Narrative

Date: July 31, 2026
Project: 24047 – NKU Civic Center Renovation
From: Jeff Fackler
Narrative: Addendum C

A1.11 – Overall Dimension Plan – Upper Level

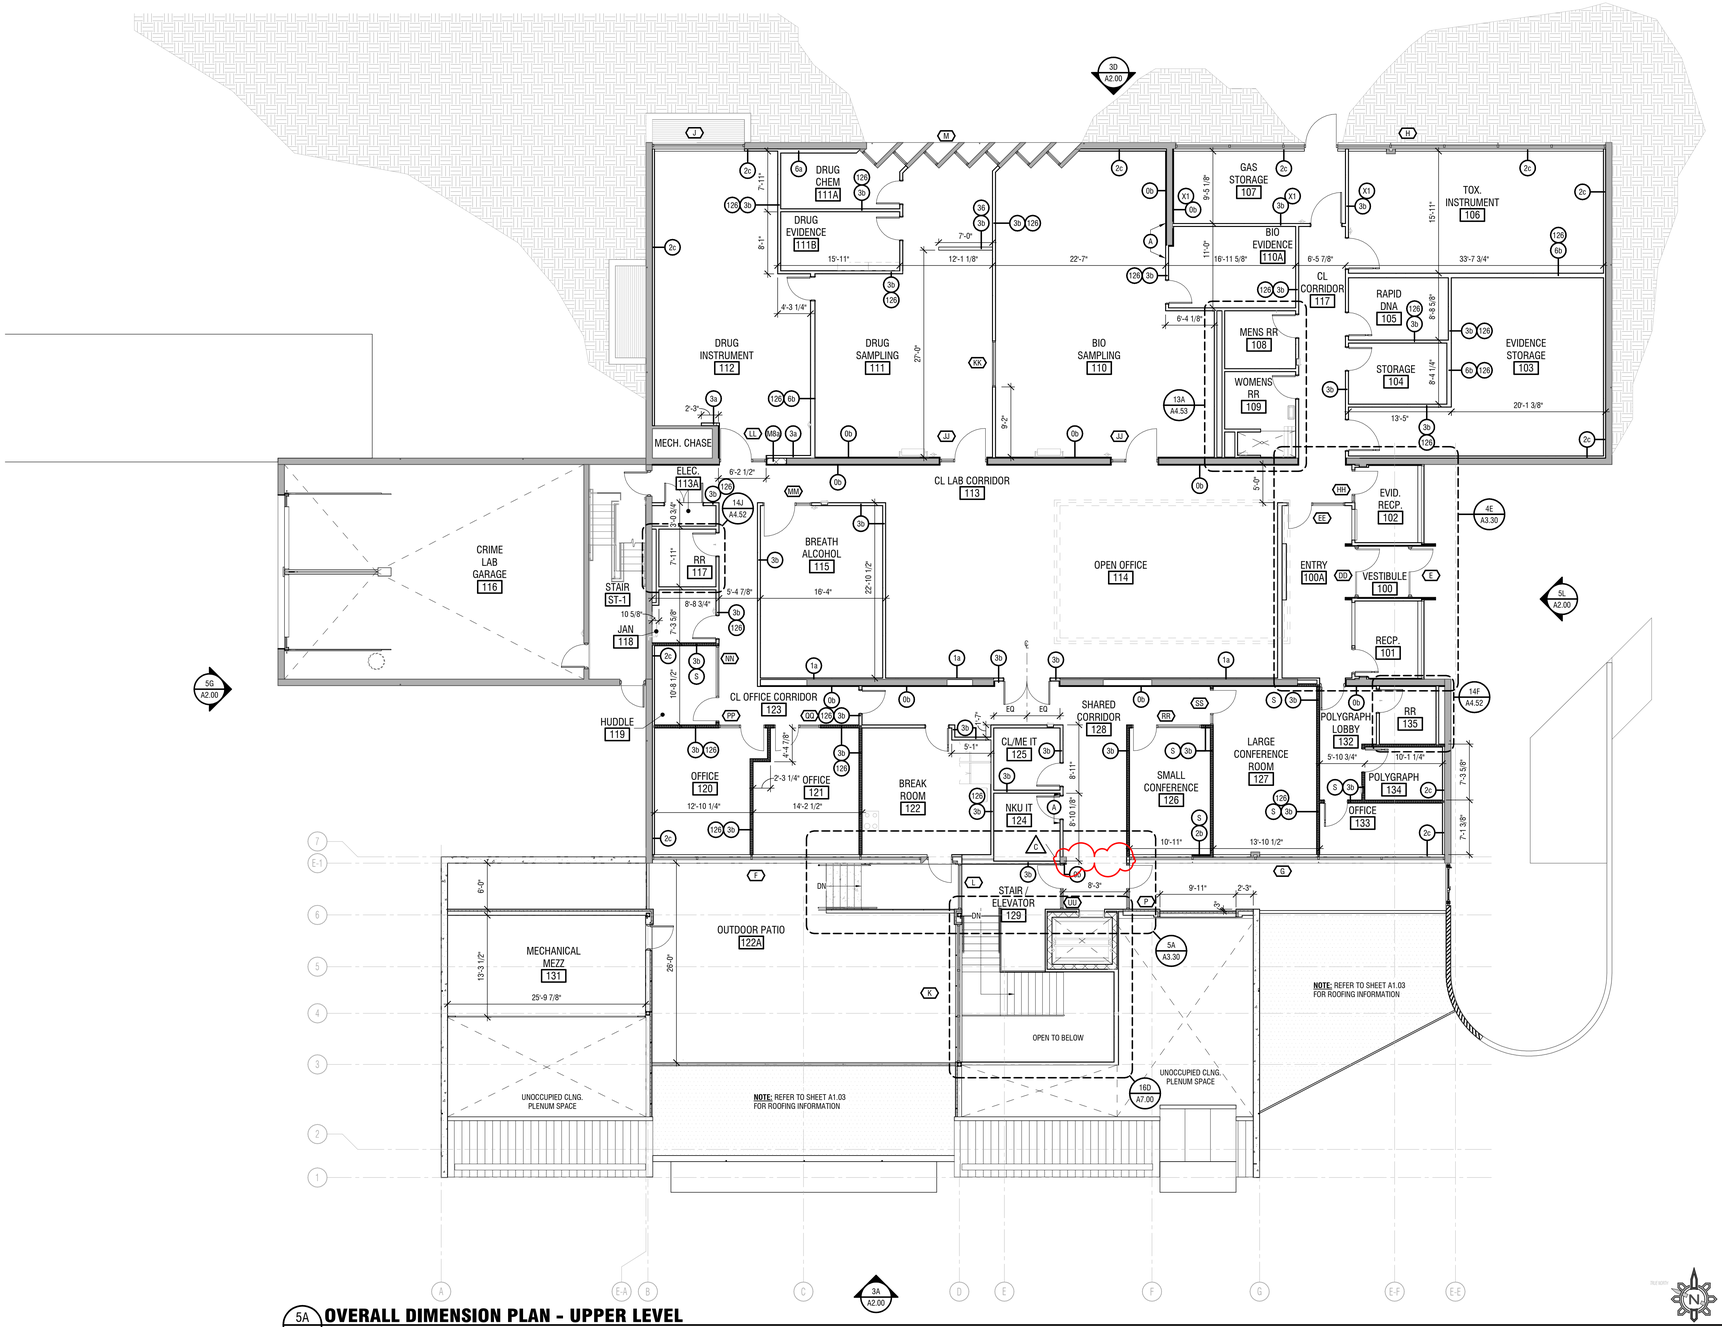
Revise extents of opening by elevator.
Add General Note to patch existing concrete floor smooth at all demolition locations.

A1.41 - Overall Finish Plan - Lower Level

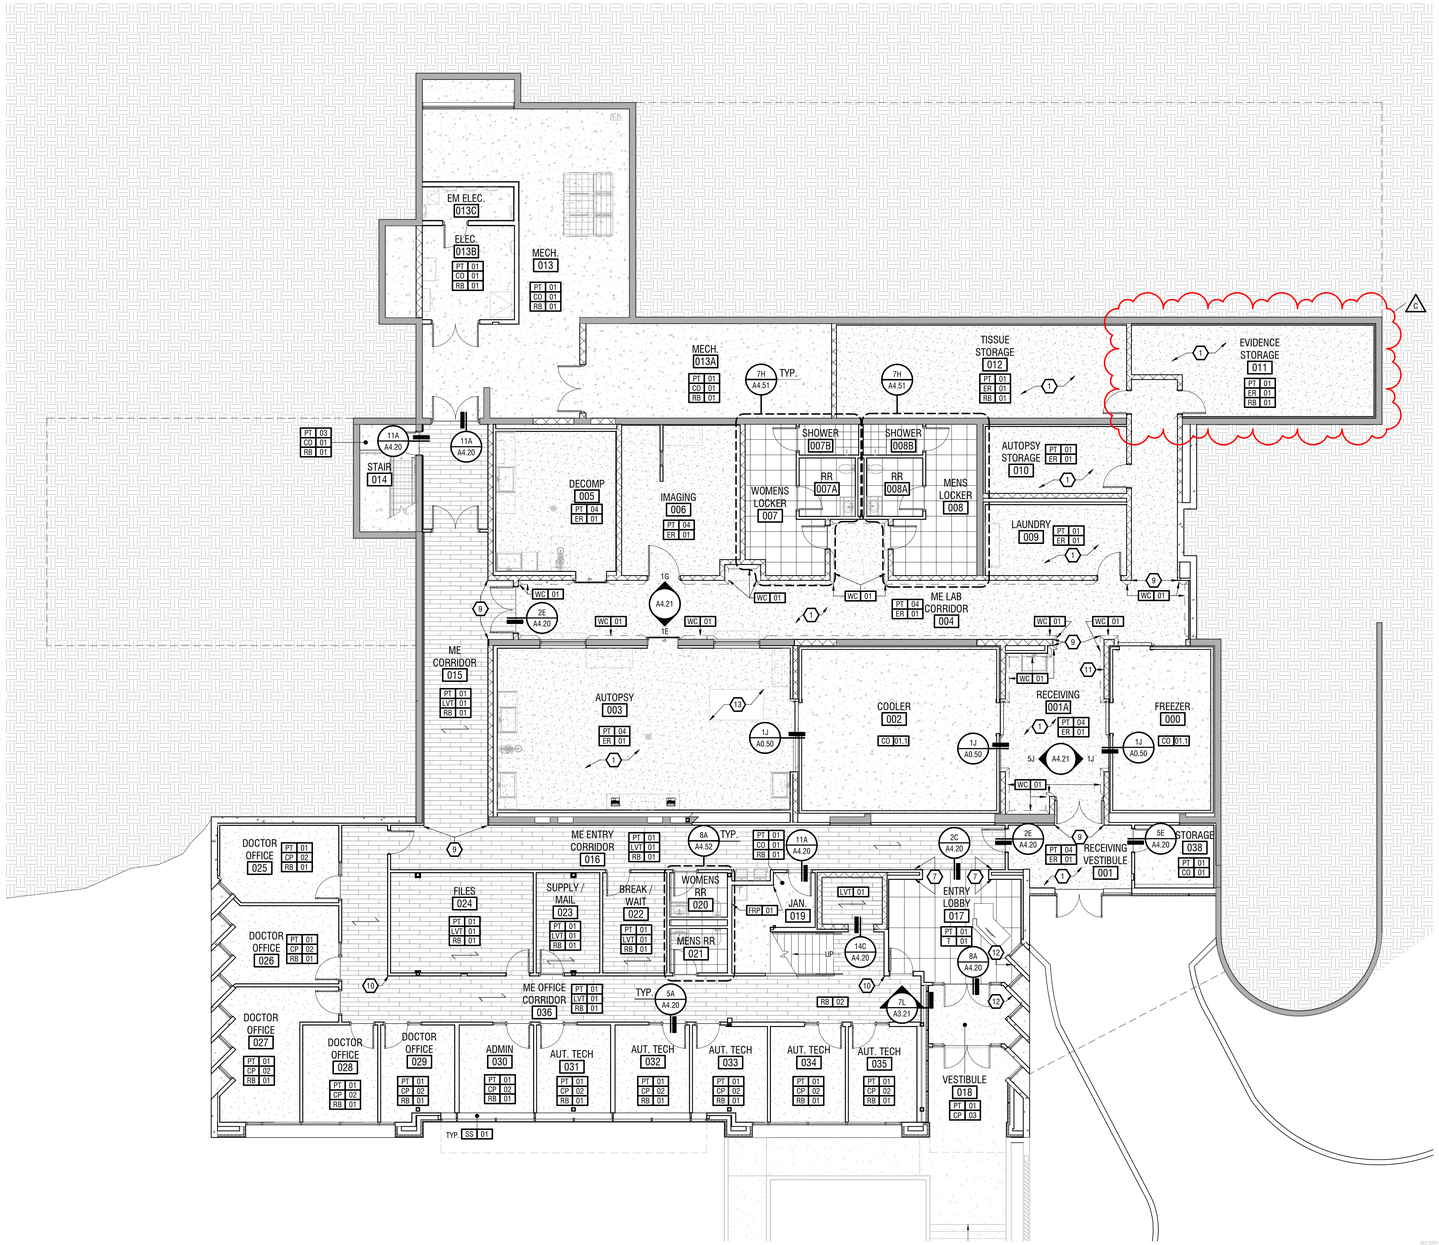
Change floor finish of Evidence Storage 011 to Epoxy Flooring.

A1.42 - Overall Finish Plan - Upper Level

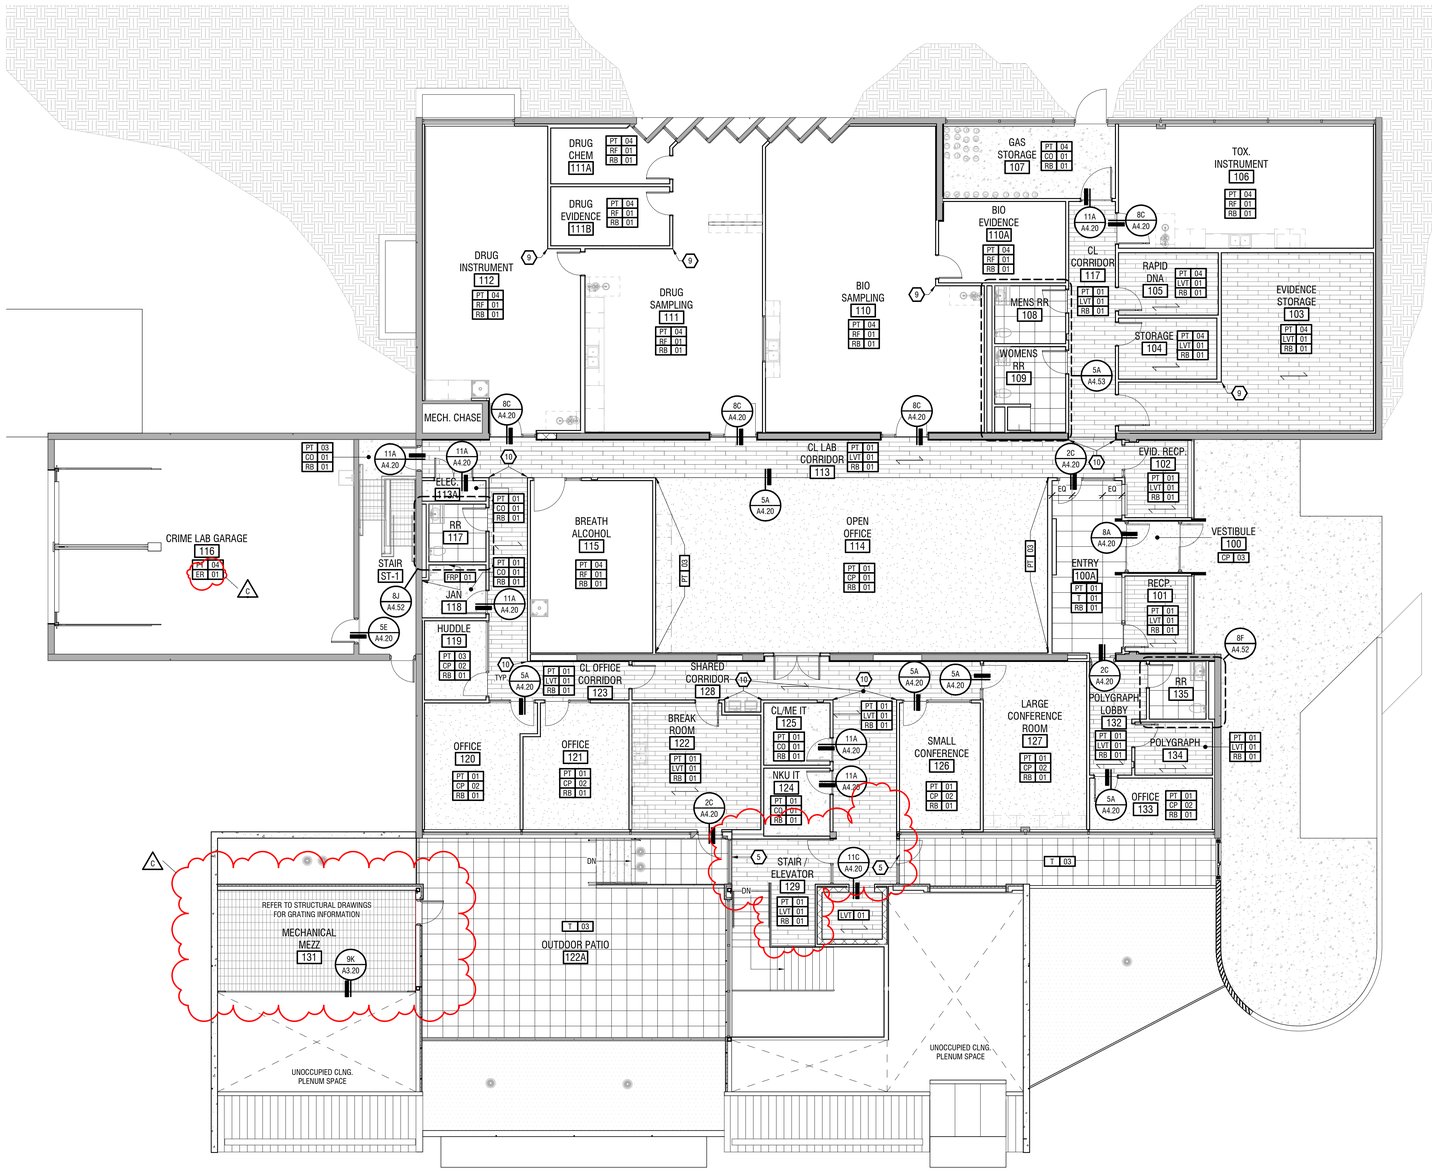
Clarify floor finish of Mechanical Mezzanine 131 to be structural grating as defined by the structural drawings.
Revise floor finish of Stair/ Elevator 129 to be LVT 01.
Revise floor finish of Crime Lab Garage to ER-01.

Answer
This is an error. The floor finish for the Crime Lab Garage should be ER-01.

A1.51 – Overall Equipment Plan – Lower Level

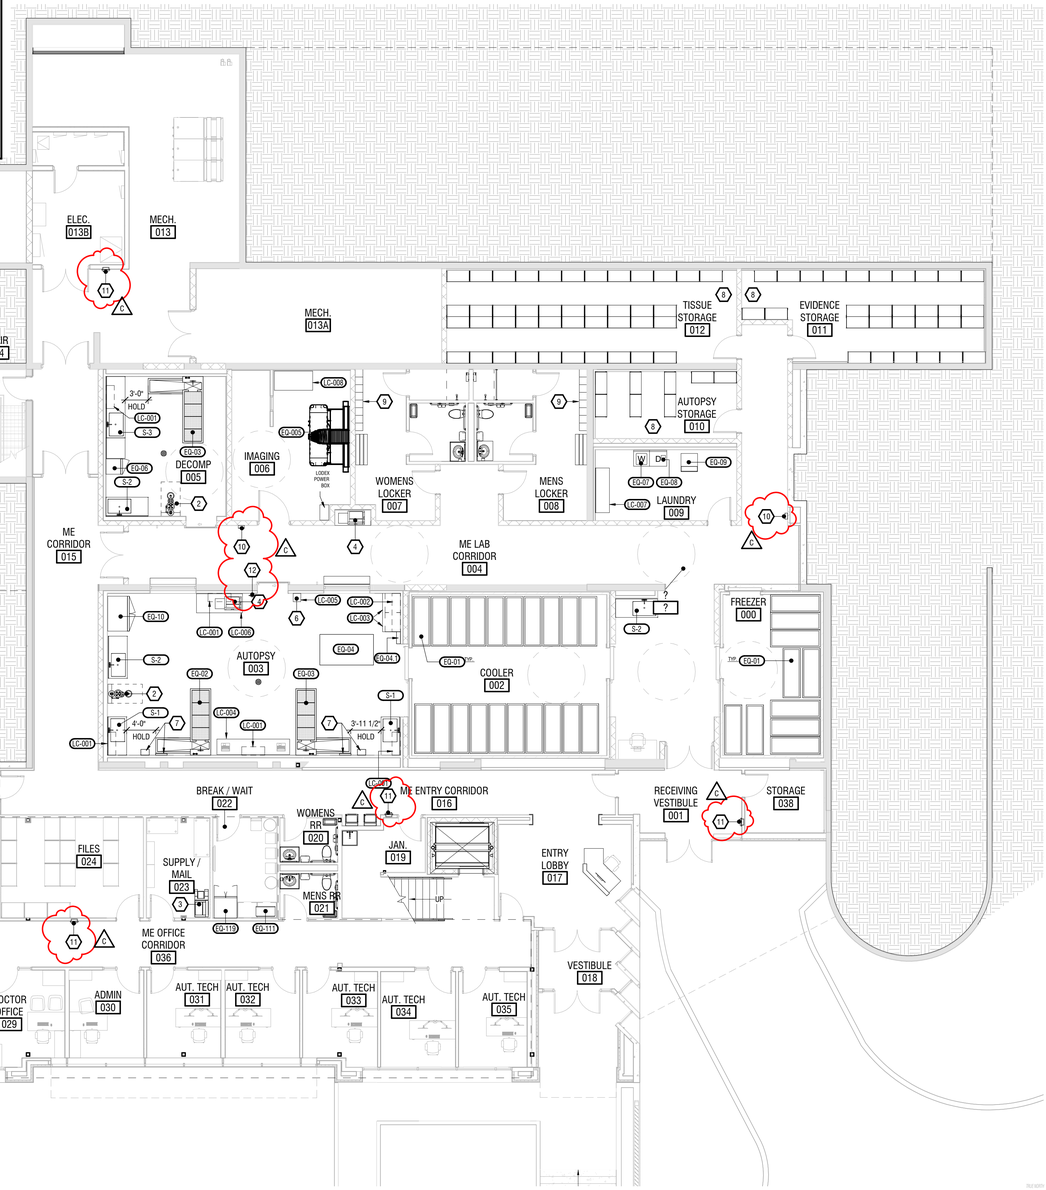
Add keynotes for locations of all fire extinguishers and cabinets.

3D A3.20 DTL - INTERNAL GUTTER @ EXISTING WALL
3" = 1'-0"

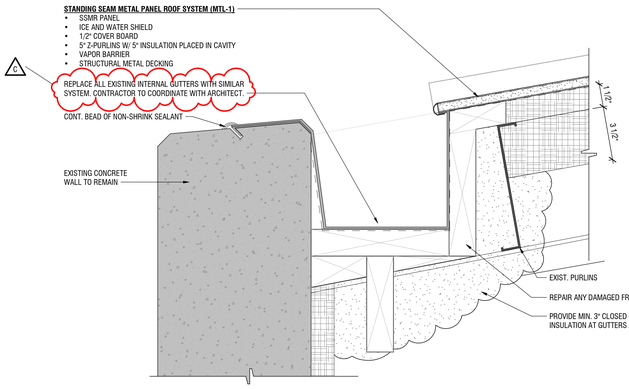
PC-0057 Gutters replacement
On sheet D1.03, note D55 calls for existing internal gutters to be replaced. Detail 3D - A3.20 calls for existing SS gutters to remain, "Patch and repair as neccessary." Are these gutters needing a full replacement or are we to go off detail 3D - A3.20?
Answer
The note on A3.20 is incorrect.

Revise note to indicate that the gutters should be fully replaced.

M1.02 – Upper Level - Air Distribution Plan

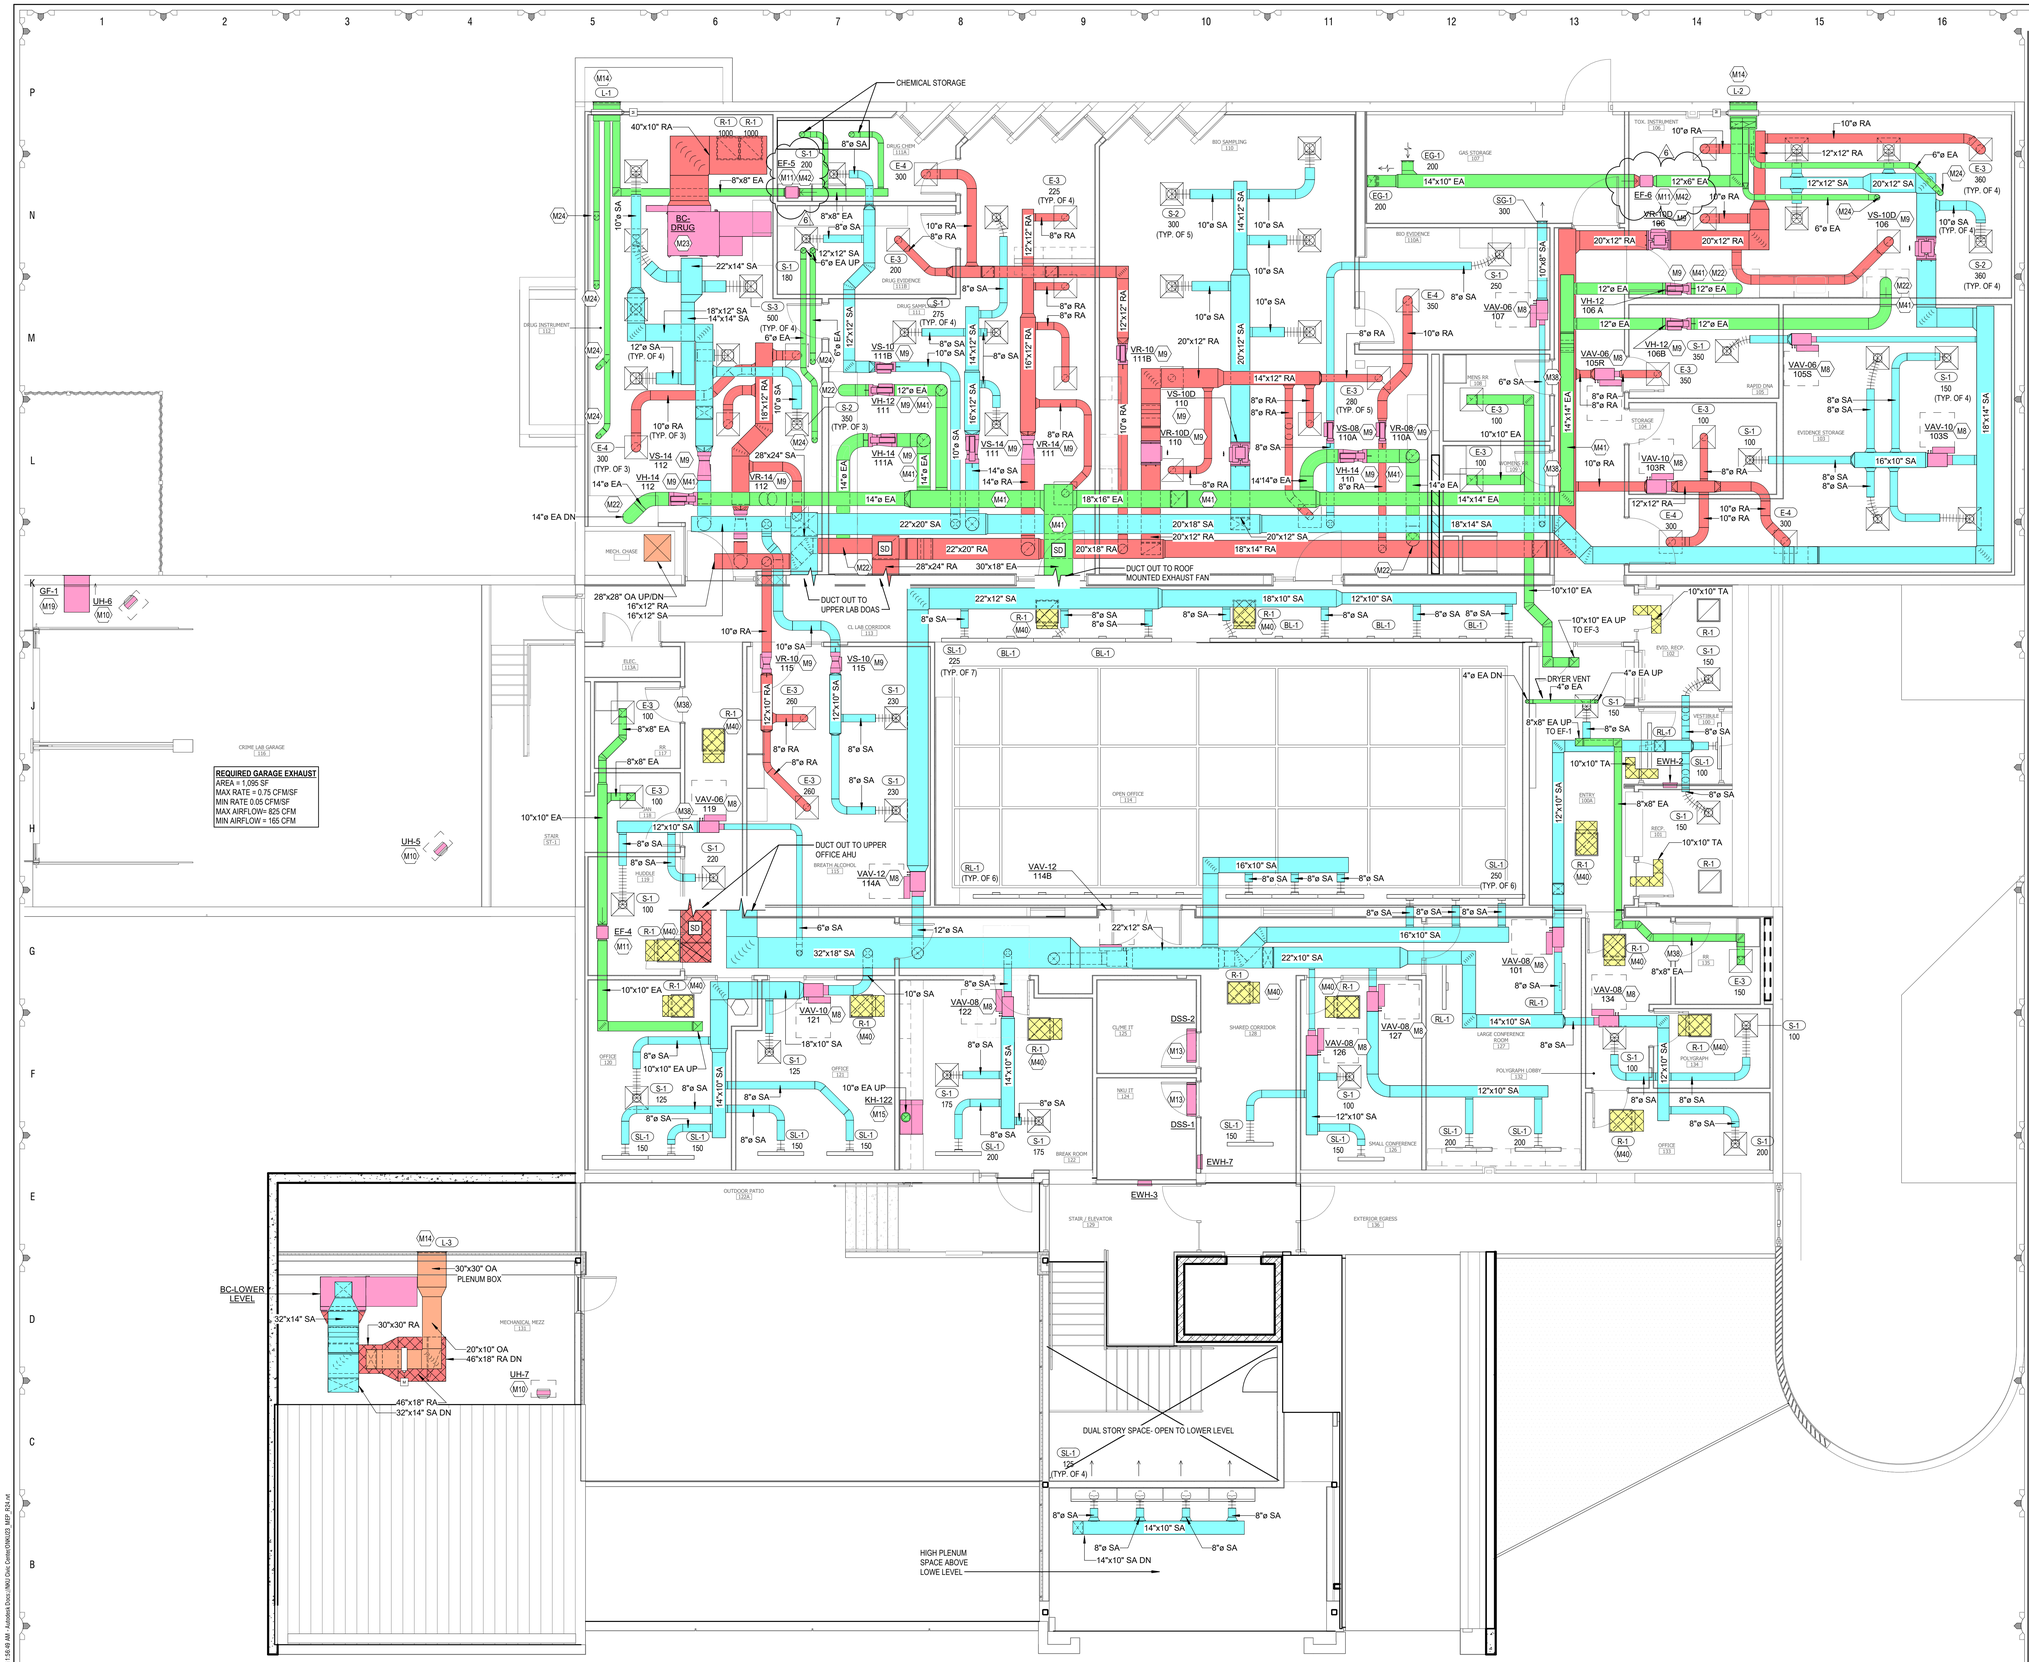
Add keynote included to call out spark B construction for EF-5 and EF-6 per RFI#34.

Should fans EF-5 and EF-6 be spark proof? Is galvanized duct acceptable for these systems?
Answer
Yes, these fans should be spark-proof. This change will be captured in forthcoming Addendum C.
